RE: Development of Regional Impact Review
The Mill at Covered Bridge

Preliminary Report:	June 14, 2004	DEVELOPMENT OF REGIONAL IMPACT REVIEW REPORT	Project:	The Mill at Covered Bridge # 533
Final Report Due:	July 14, 2004		Comments Due By:	June 28, 2004

RE: Development of Regional Impact – The Mill at Covered Bridge (DRI 533)
Plan Review Comments & Recommendations

Preliminary Plan

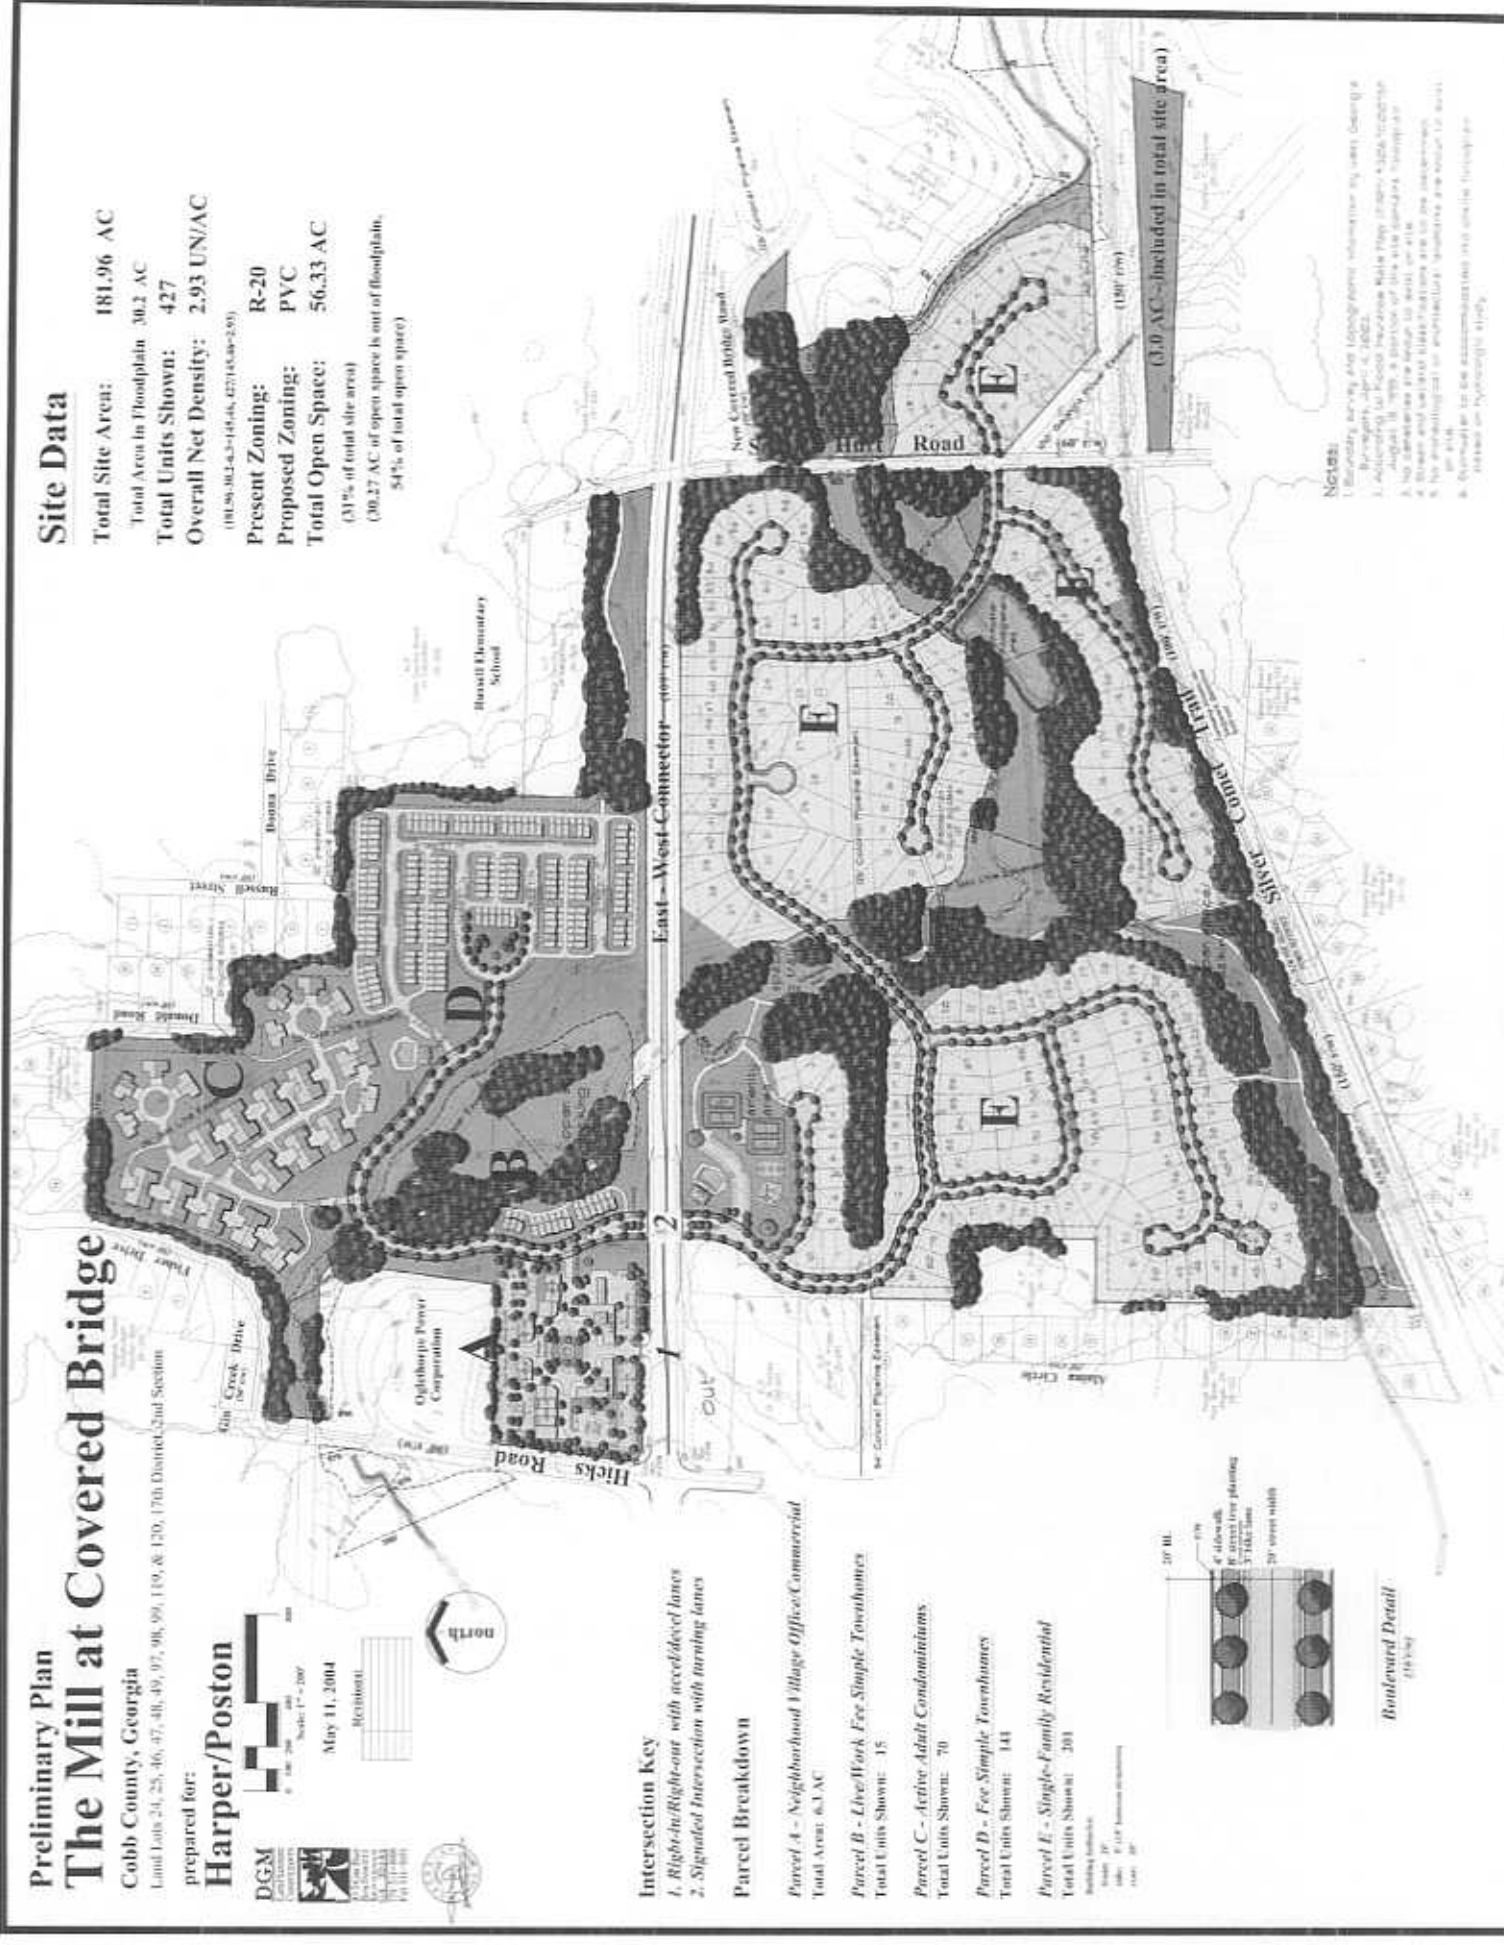
The proposed development meets many of the ARC's regional development policies. Further refinement of the site plan could lend the development to better promote and implement many of the goals set forth in the Regional Development Plan. Best Transportation Practices 9 and 10 emphasize providing effective pedestrian and bicycle connections. Revising the site plan to better meet these best practices would greatly enhance connections, particularly to adjacent land uses. For example, direct pedestrian access to Russell Elementary School should be considered. Coordination with the Cobb County School Board is strongly encouraged. Vehicle connectivity to adjacent land uses should also be considered where applicable; for example, extending Russell Street and Donald Street into the development.

Regional Development Policies 8 and 9 recommend protecting environmentally sensitive areas and creating a greenspace network. Activity and land disturbance alongside the Silver Comet Trail should be kept to a minimum. It is strongly encouraged that adequate buffers are provided along the trail. Consideration should be given to the realignment of Street F to minimize the activity in close proximity to the trail. Pedestrian access from the site to the Silver Comet Trail is proposed. It is also encouraged that activity and land disturbance alongside and in streambeds and wetlands be minimized.

The property is not near the Chattahoochee River Corridor, but it is in the Chattahoochee Basin. The project property is crossed by a tributary to Nickajack Creek, which is in turn a tributary to the Chattahoochee River. As such, the property is subject to the Cobb tributary buffer zone ordinance for streams draining into the Chattahoochee, as required under the Metropolitan River Protection Act, as well as the Cobb County stream buffer ordinance. The buffers under the Cobb ordinance vary with the size of the basin. The site plan should show the required buffers along all applicable streams.

In reviewing this development proposal, the design of this mixed-use plan includes a new roadway connection (Street A) along the East-West Connector, which may create additional vehicular impacts during the morning and afternoon peak periods. Factoring the existing morning peak period congestion that already exists along the East-West Connector, the developer should consider necessary vehicular mobility improvements (extended left-turn & right-turn deceleration lanes, enhanced signalization, etc.) as a condition for this new median break entrance design. The proposed left-turn deceleration lane considered along the East-West Connector into the southern portion of the development should be designed to not impede the westbound vehicular through movement progression during the evening peak period.
